**Re: Office Addition, 1121 San Mateo Blvd NE, Traffic Circulation Layout
Engineer's Stamp dated 2-19-14 (J17-D034)**

**Re: Office Addition, 1121 San Mateo Blvd NE, Traffic Circulation Layout
Engineer's Stamp dated 2-6-14 (J17-D034)**

**Re: Office Addition, 1121 San Mateo Blvd NE, Traffic Circulation Layout
Engineer's Stamp dated 2-6-14 (J14-D034)**

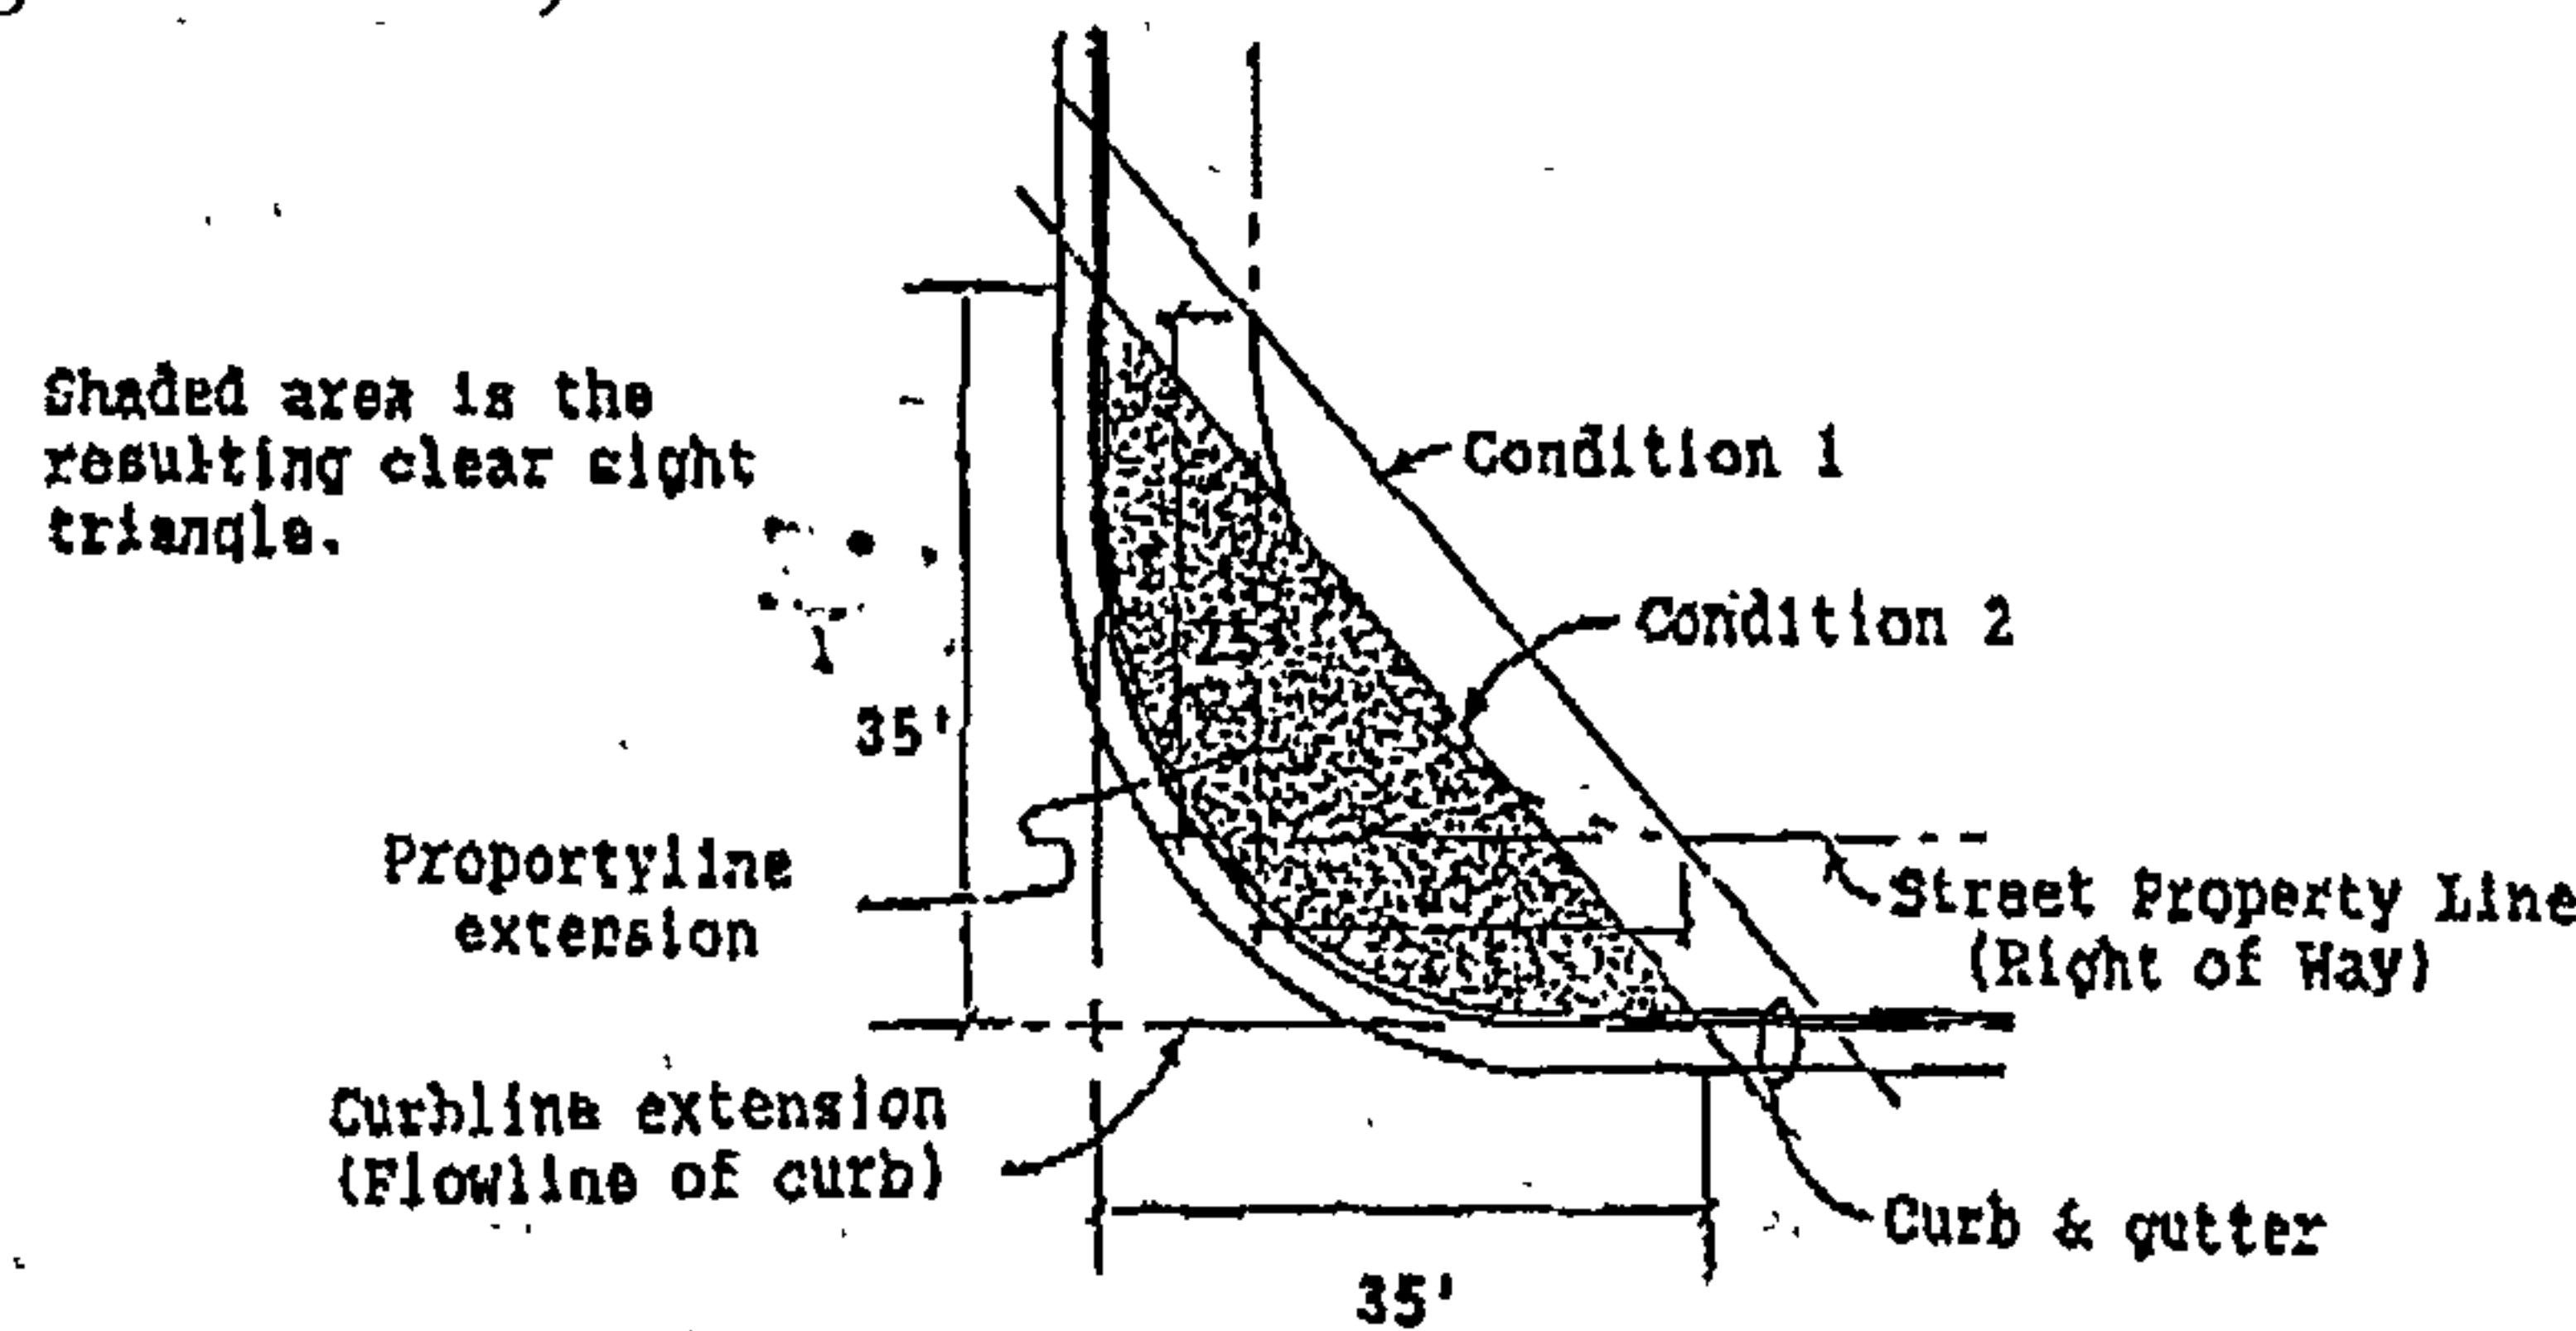
Based upon the information provided in your submittal received 2-06-14, the above referenced plan cannot be approved for Building Permit until the following comments are addressed:

1. The development of this site must be in compliance with current DPM and ADA standards and regulations.
2. Define width of the existing sidewalk fronting San Mateo Blvd.

3. Is there a continuous ADA Pedestrian pathway provided at the existing entrance fronting San Mateo Blvd? Current DPM standards require ADA compliant ramps and crossings at entrances, especially along major arterials with bus routes and pedestrian traffic.

4. Per the DPM, a 6 ft. wide ADA accessible pedestrian pathway is required from the public sidewalk to the building entrances. Please clearly show this pathway (See comment 6)

5. Per the DPM, a 6 ft. wide ADA accessible pedestrian pathway is required from the HC parking stall access aisles to the building entrances. (See comment 6)

6. Please clarify where the building entrance is located and show door swing. Is the new awning cantilevered or ground supported? This information is needed to clarify if the proposed 6 ft wide ADA accessible pedestrian pathway is unobstructed.

7. Parking spaces cannot cross over the lot lines. The current and proposed parking must be moved off of the City Of Albuquerque Right-of-Way (COA ROW) or a Revocable Encroachment Permit, issued by the City, must be obtained. Please contact Jane Rael regarding encroachment permits at 924-3992.

8. List radii for all curves shown; for passenger vehicles, the minimum end island radius is 15 feet.

9. It appears that restriping of all parking stalls and end-islands will be necessary. Will the existing asphalt be top-coated or old striping removed?
10. The proposed parking and landscaping may interfere with the sight distance of the intersection. Please provide a sight distance exhibit (see the *Development Process Manual, Chapter 23, Section 3, Part D.5 Intersection Sight Distance*).

11. Please add the following note: "Landscaping and signing will not interfere with clear sight requirements. Therefore, signs, walls, trees, and shrubbery between 3 and 8 feet tall (as measured from the gutter pan) will not be acceptable in this area."
12. Work within the public right of way requires a work order with DRC approved plans. (Alley is COA ROW)
13. Alley must meet COA Standard (DWG # 2428) which includes alley intersection w/ ADA ramps, alley gutter and pavement for the full length of the property and 20 ft minimum width.
14. The refuse can not be located within the public ROW.
15. Please refer to all applicable city standards.
16. Please ensure all ramps are ADA compliant.
